ONE SYDNEY HARBOUR

BARANGAROO

R4A SUPPLEMENTARY DESIGN STATEMENT

June 2019

Plantroom Facade - 3D Diagram and Plan - Proposed

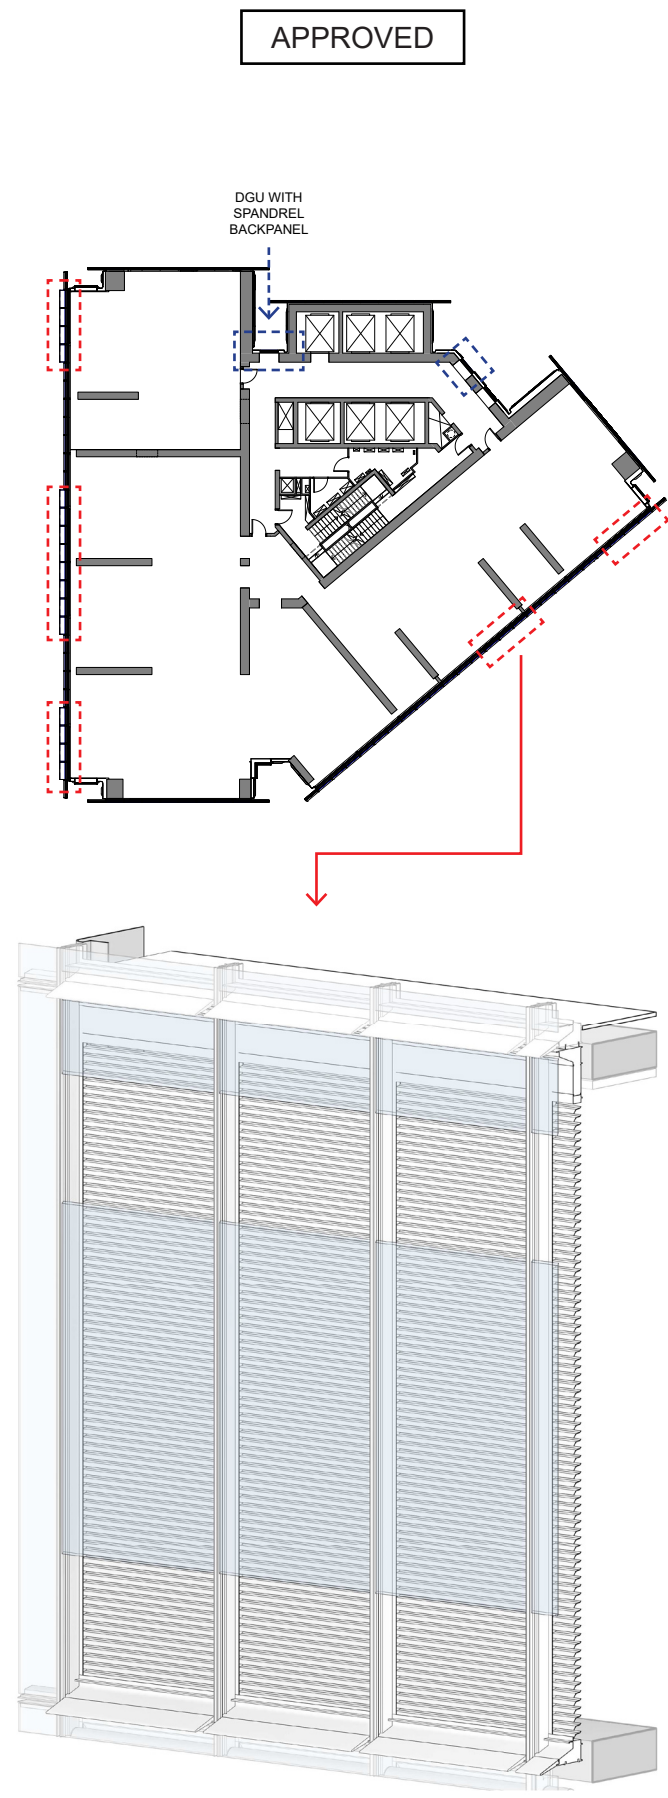
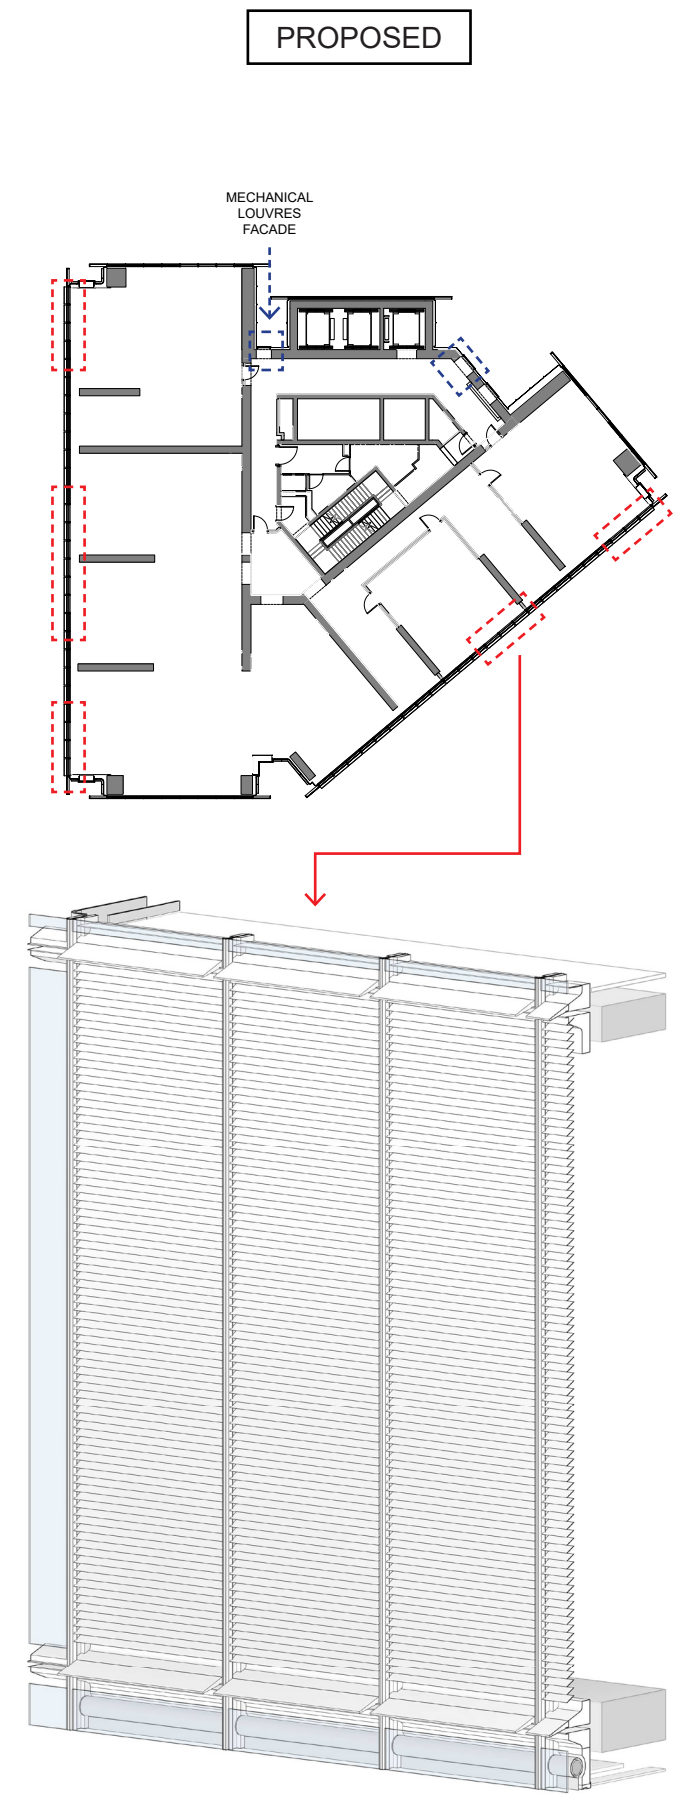
Following design developments in the mechanical services system, it was established that there is a requirement for additional ventilation within the plantrooms. To achieve this, the glass panels that sit in front of the louvred facade panels in the approved design are proposed to be removed as part of this modification. This will allow for additional free open area per louvred facade panel and thus enable the design to meet the increased mechanical demands.

A second proposed change is the addition of two extra panels of ventilated louvres along the southern and southeastern façades. These modules substitute the previous spandrel panels that are approved in these locations (highlighted by the blue dashed lines in the adjacent plans). This second amendment is also driven by the need for extra ventilation.

Proposed - NE-Elevation

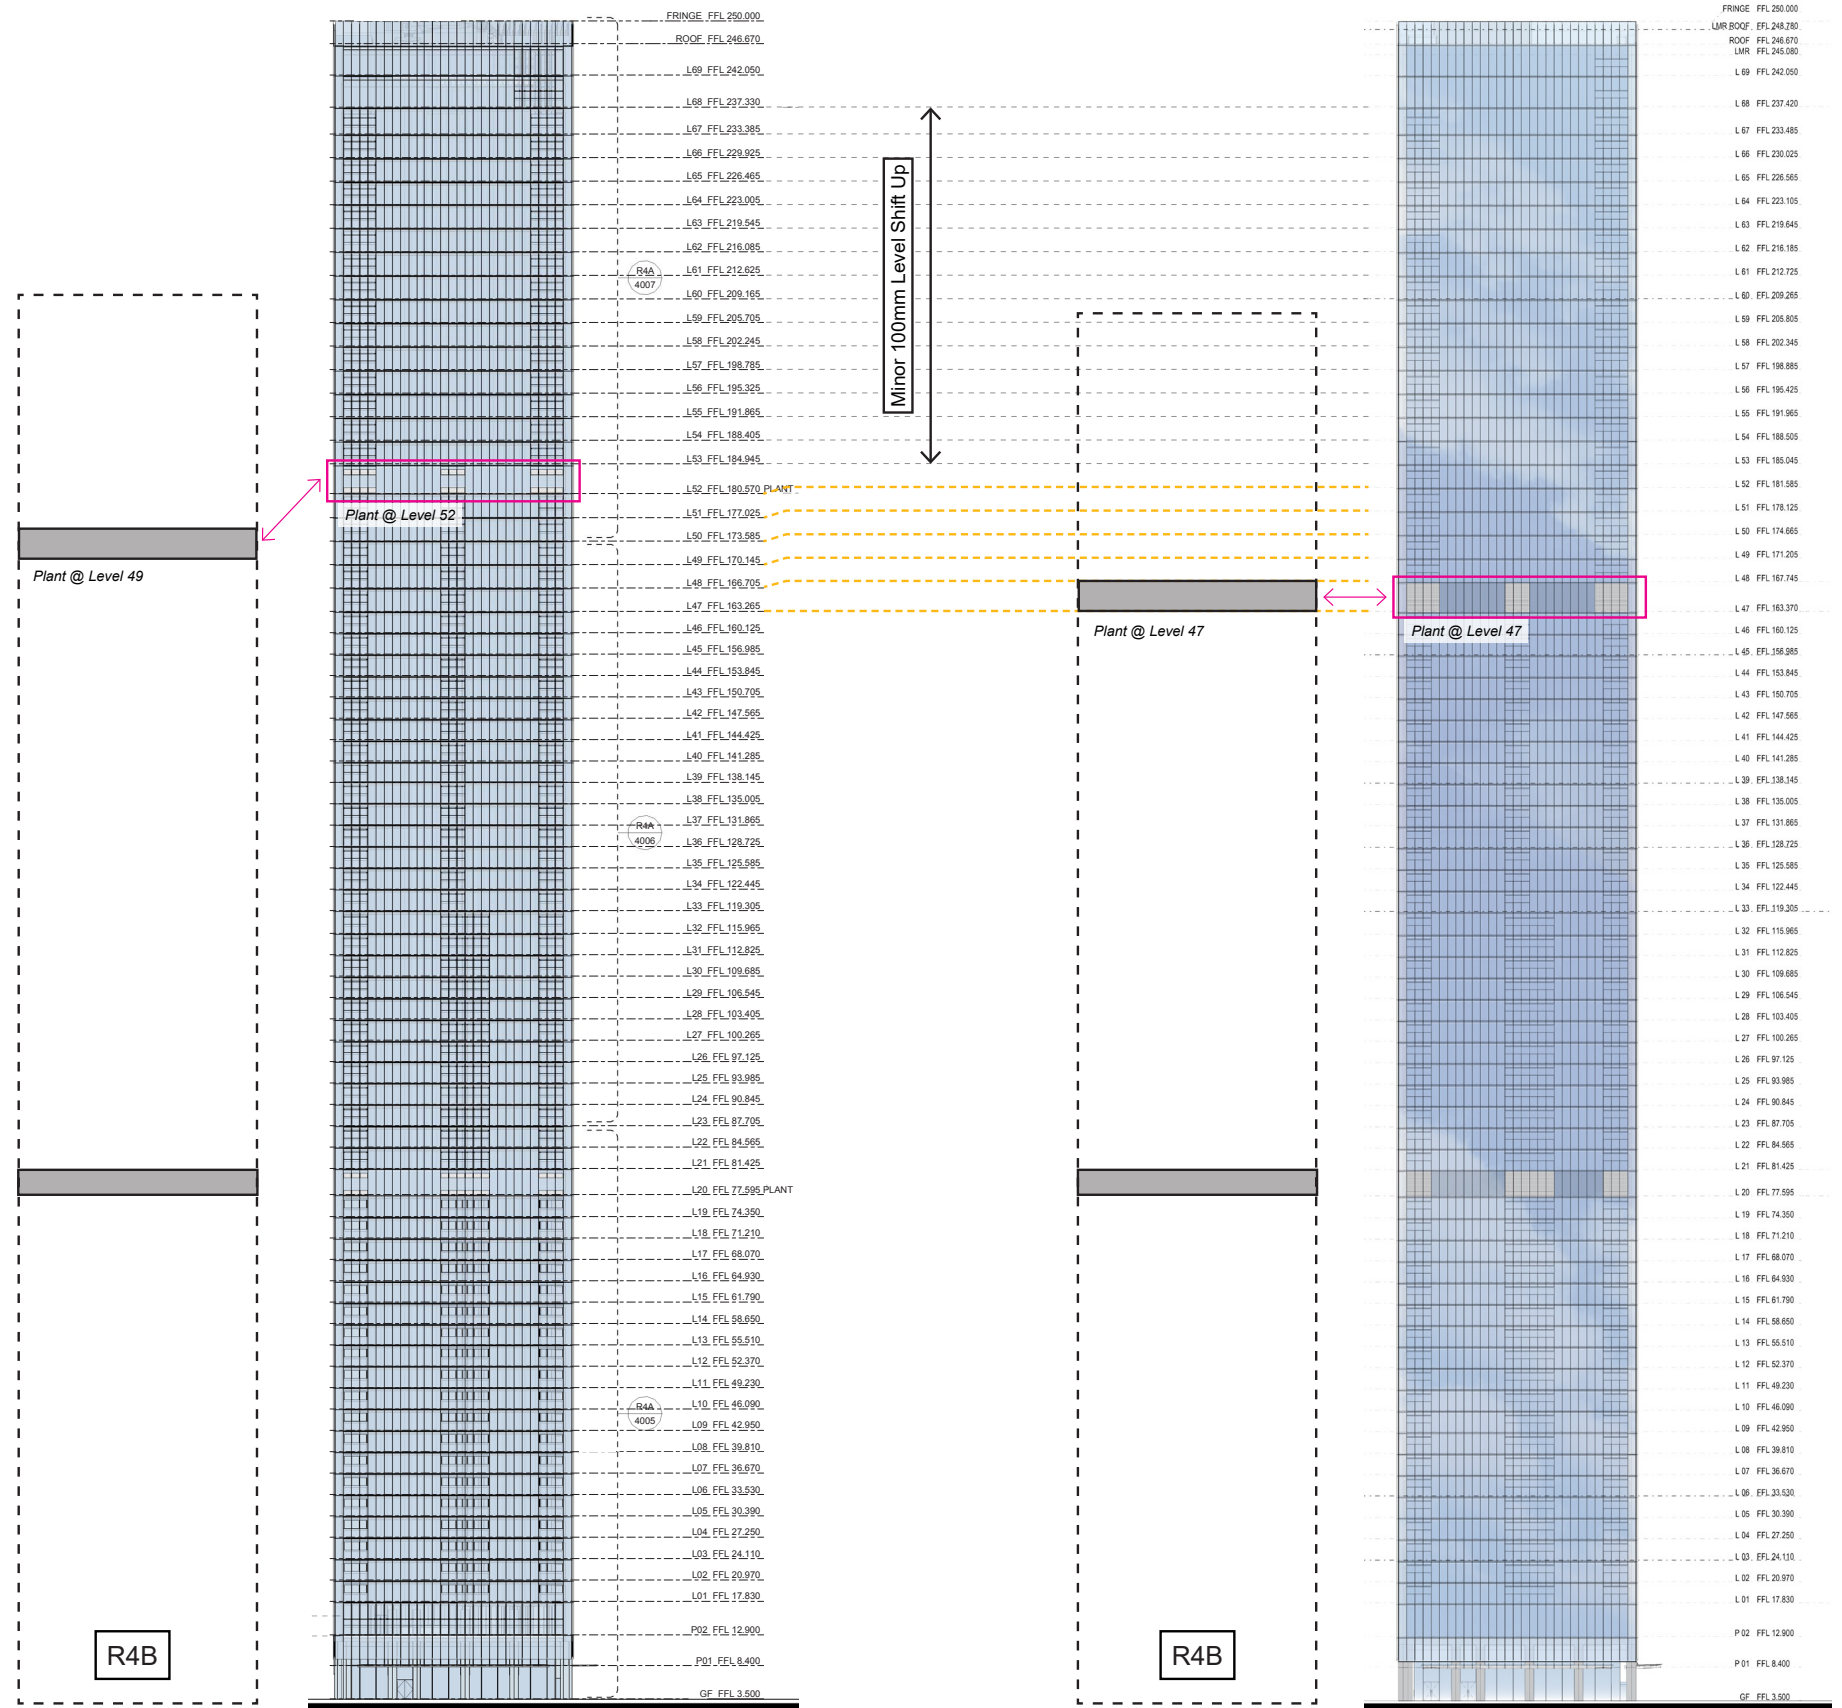
As previously mentioned in Section 2.1, the plantrooms of both R4A and R4B are proposed to be shifted in level to match each other.

The elevations to the left show this alignment and also how they relate to the adjoining floor levels. The dashed yellow lines in the adjacent elevations represent the most substantial changes. These are a consequence of the aforementioned change from a mid-plate layout to an upper-plate layout on these particular levels.

The dashed grey lines indicate minor revisions (a consistent 100mm shift upwards), which is again a consequence of this proposed revision.

Proposed Double Height Facade - Section

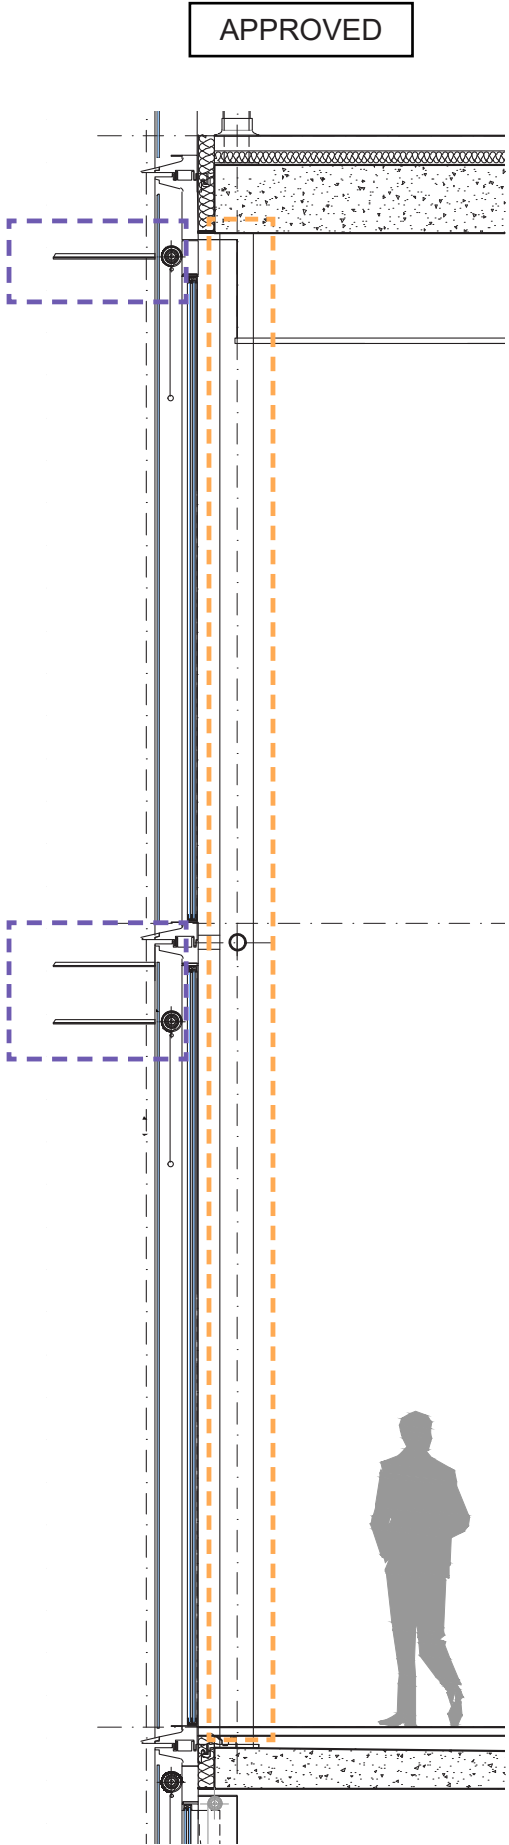
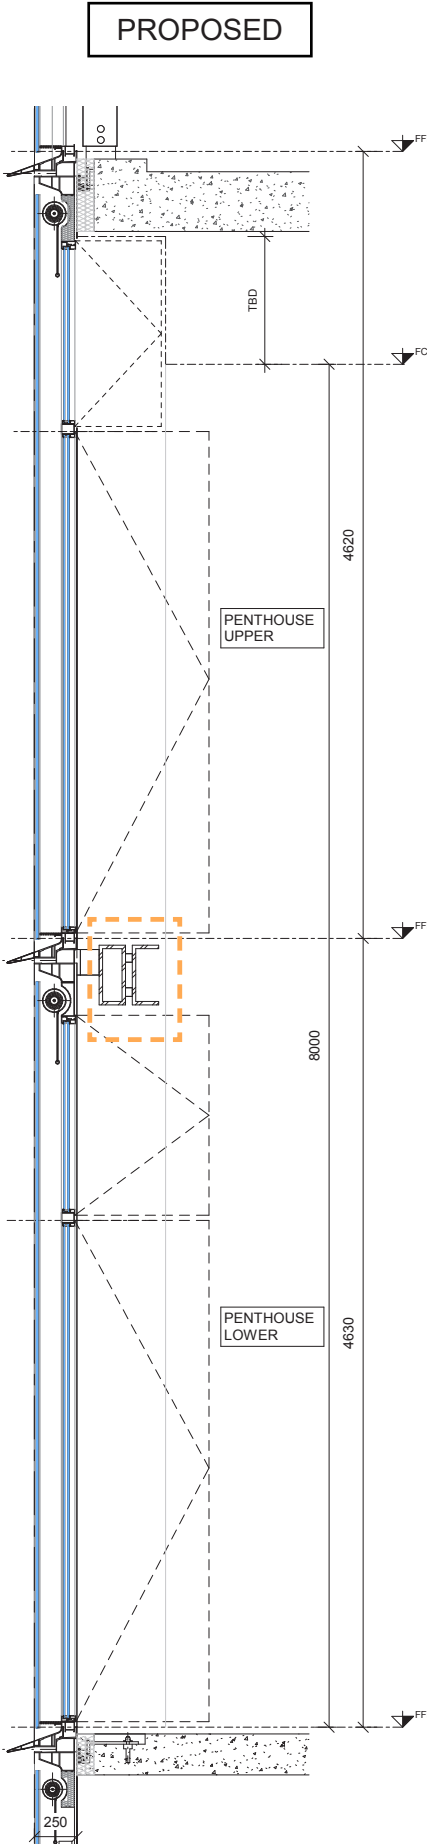
The penthouse apartment features double-height spaces at both its northeastern and northwestern corners. Following a design development process, two amendments are proposed for the facade system that is featured in these spaces.

The first amendment relates to the approved sun shades which are shown highlighted in purple in the adjacent section. Following a lengthy review of the performance of the facade, these sunshades were deemed to be unnecessary and so it is proposed that they be removed. Noting that this is the only location on the project where these sunshades have been specified, the result of this change is a facade system that is more in keeping with the rest of the tower.

The second amendment refers to the design of the steel supporting frame which the double-height facade relies upon for its structural rigidity. In the approved design, a steel column is positioned behind every facade mullion. It is proposed to replace this vertical structural array with a single horizontal beam behind the stack joint (refer to the areas highlighted with dashed orange lines in the adjacent sections). This proposed change will increase views from within the apartment and allow for easier operation of the Open Cavity Facade (OCF) window system.

Proposed Penthouse West Facade

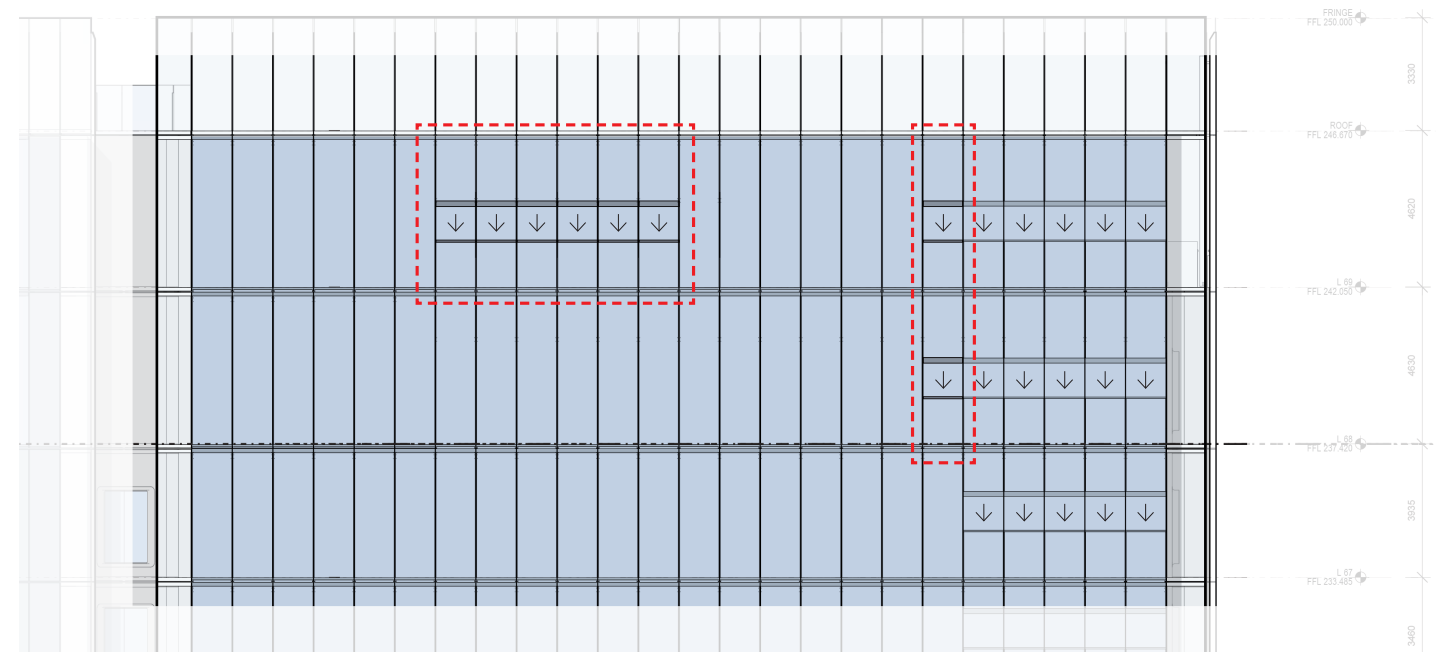
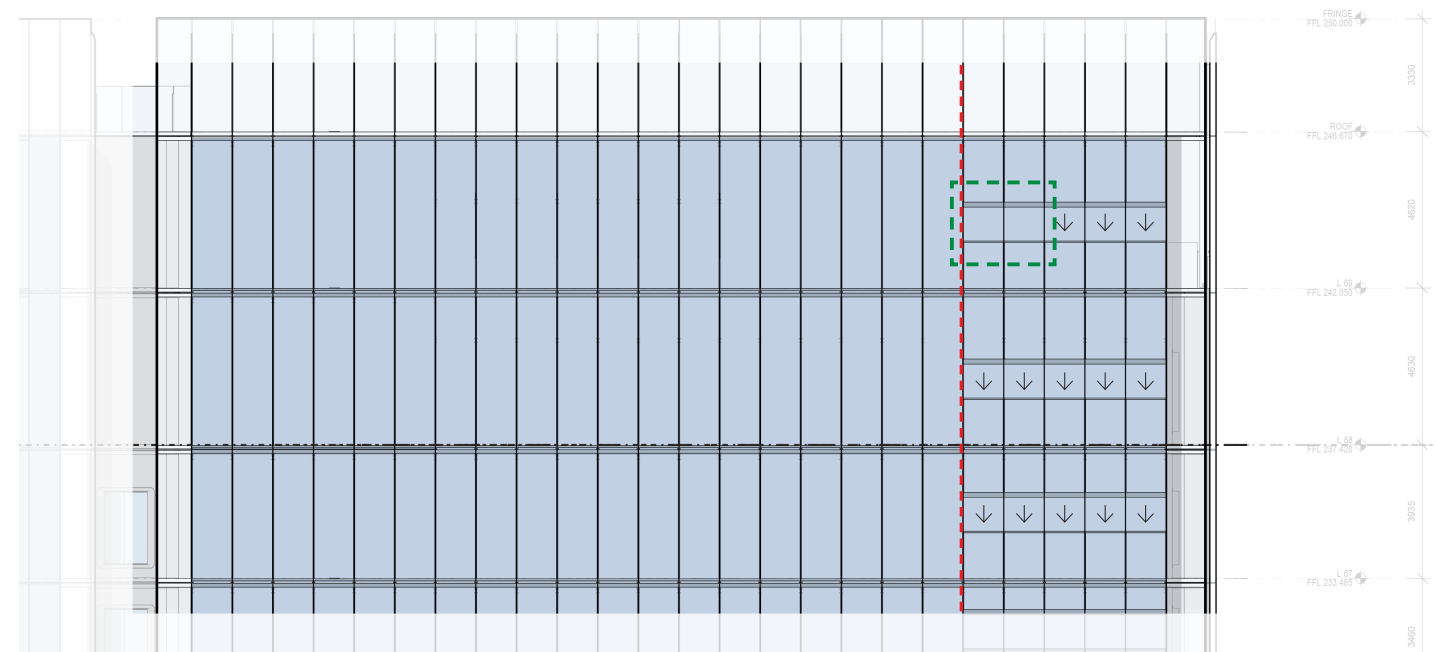
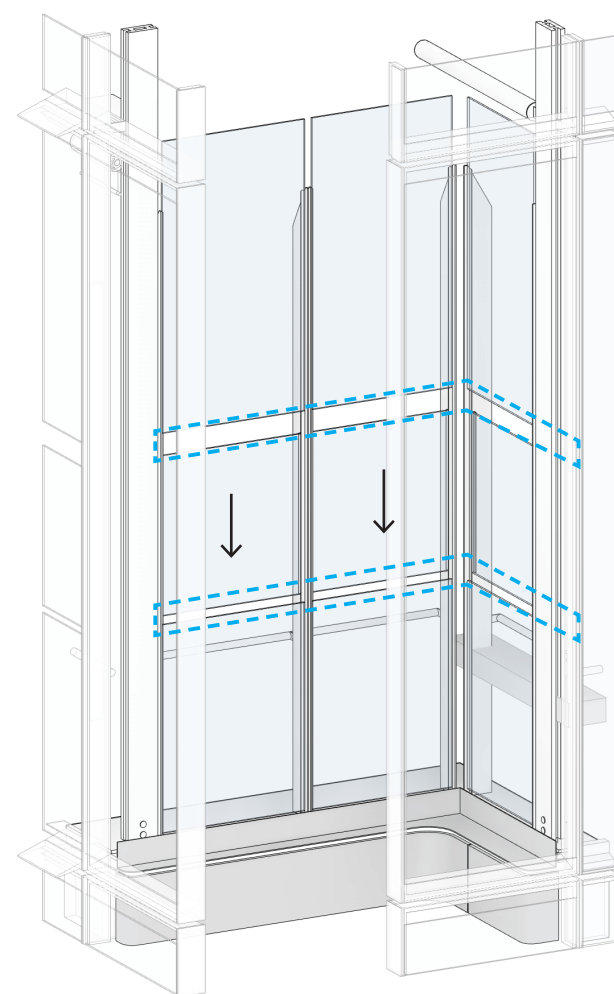
The top level of the western façade, which faces the Harbour and protects the external terrace, has several proposed amendments that are a result of the design development process as well as subsequent wind analysis.

Firstly, eight modules of the wintergarden facades (one on each level), are proposed to be changed to fixed glass panels in order to better align with the wintergardens in the typical levels below (highlighted in red in the adjacent elevations).

The two corners of the penthouse external terrace, the windscreens are proposed to be updated to allow for the inclusion of operable panels. By doing so, the previously continuous glass parapet was divided in such a way as to match the openings in the adjacent wintergarden sash windows (highlighted in blue in the diagram to the left).

Finally, on the upper level, highlighted in green, two 'wintergarden' panels are proposed to be changed to a new typology that is visually similar to the closed wintergarden system (including the size of the openings) yet will be non-operable. That is to prevent eventual falling risks given the proximity of such panels to the raised pool deck
